ADDENDUM NO. 2

23 January 2017

RE: MILLER PARK DISTRICT PHASE 1
Contract no. R-14-011-201

FROM: Spackman Mossop Michaels / Eskew+Dumez+Ripple, Joint Venture
365 Canal Street, Suite 3150
New Orleans, Louisiana 70130
(504) 561-8686

CHATTANOOGA, TN

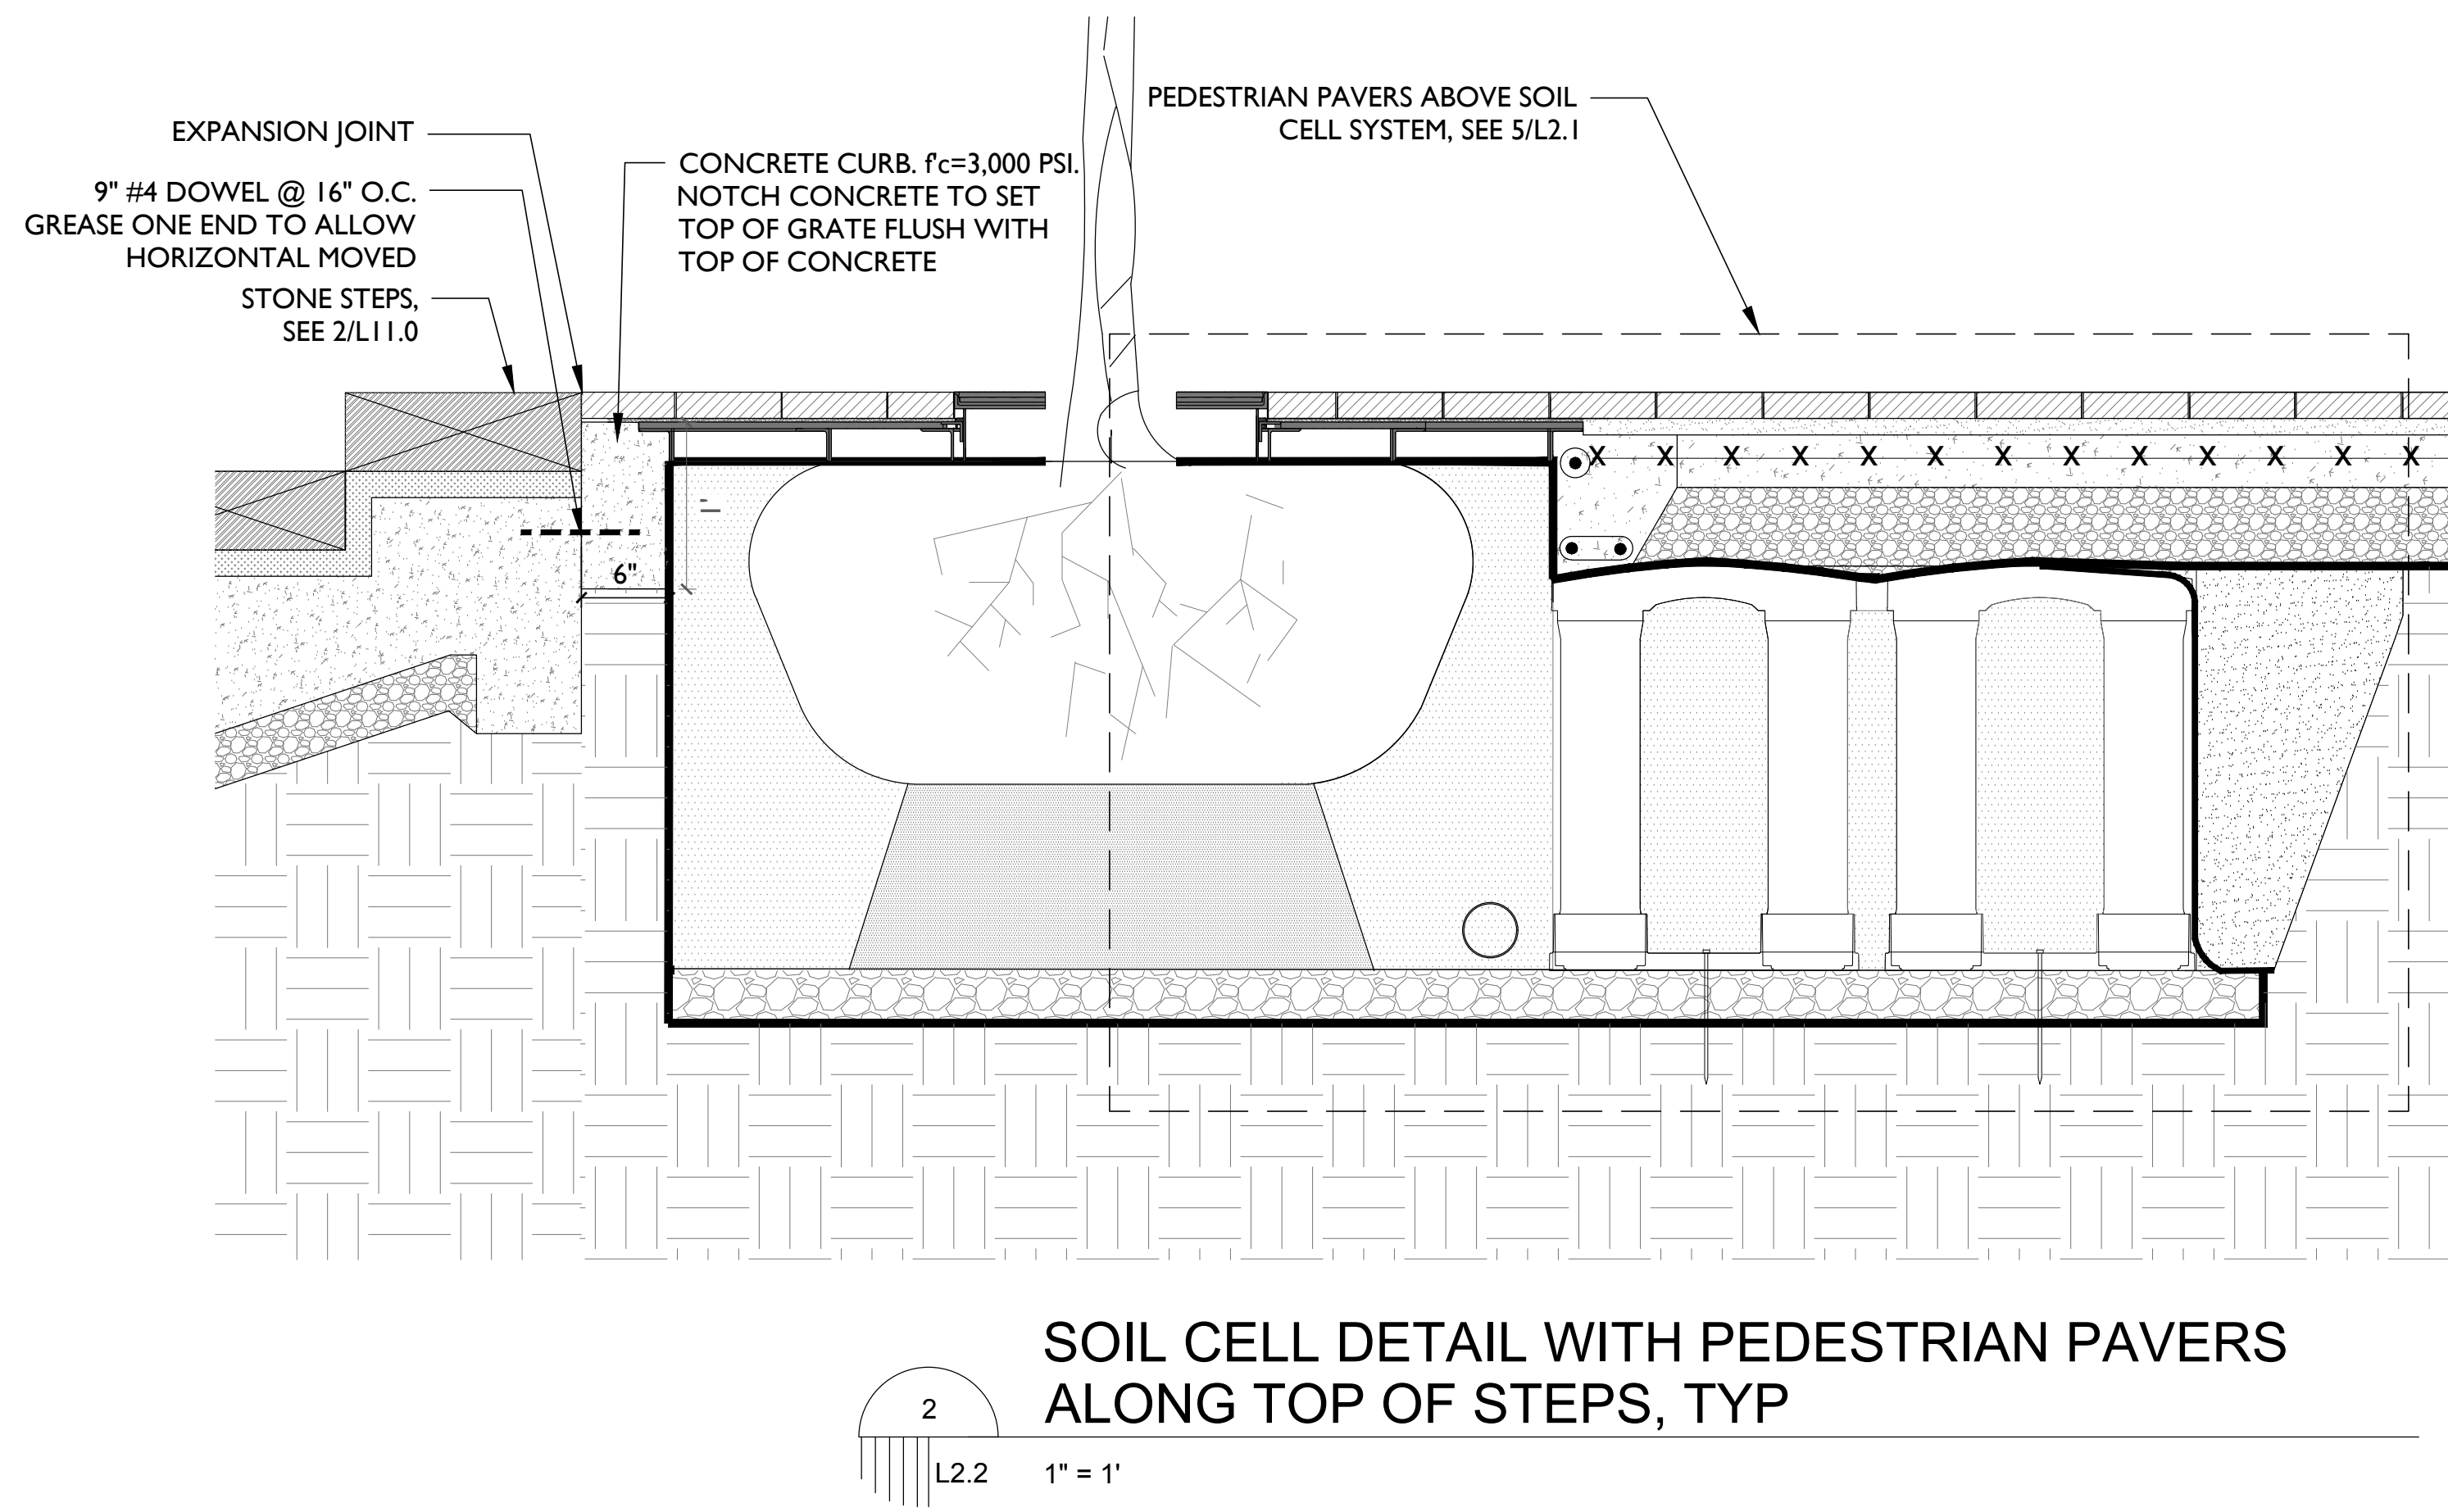
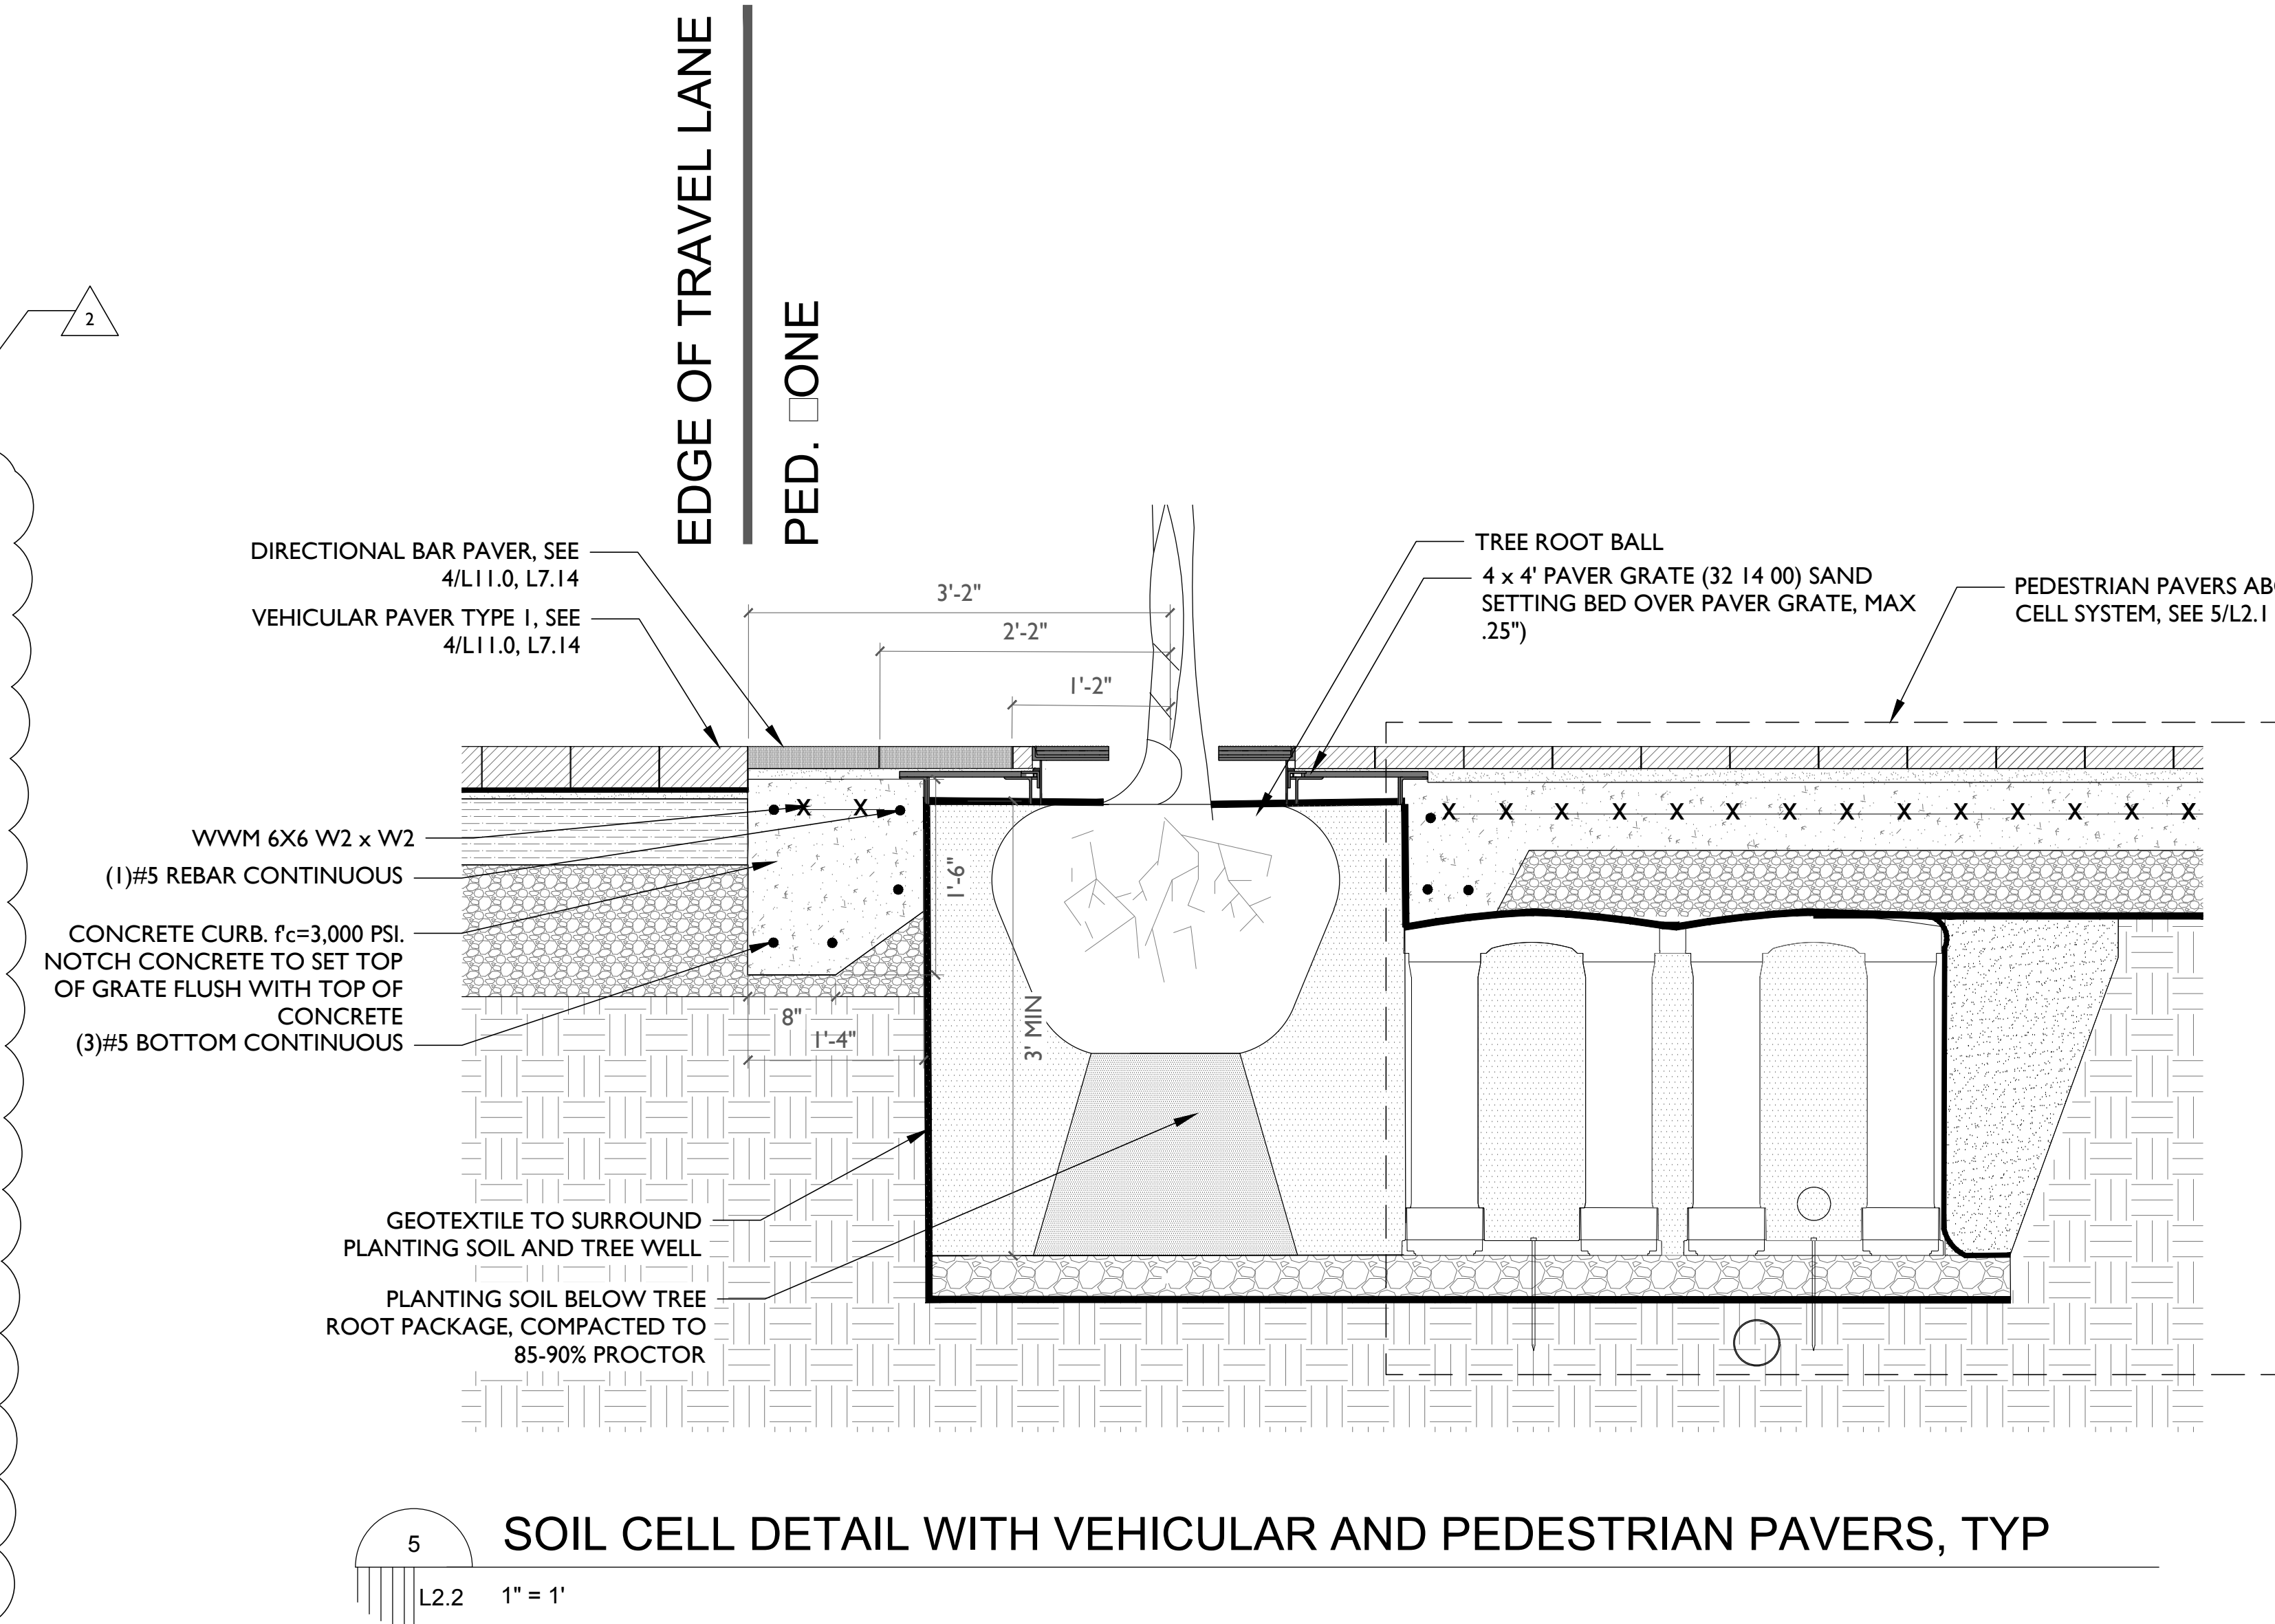
- P. L2.1- SOIL CELL DETAILS: Added title block to sheet.
- Q. L2.2- SOIL CELL DETAILS: Added 6/L2.2: Detail of Soil Cell Interaction with Light Pole and Pull Boxes.
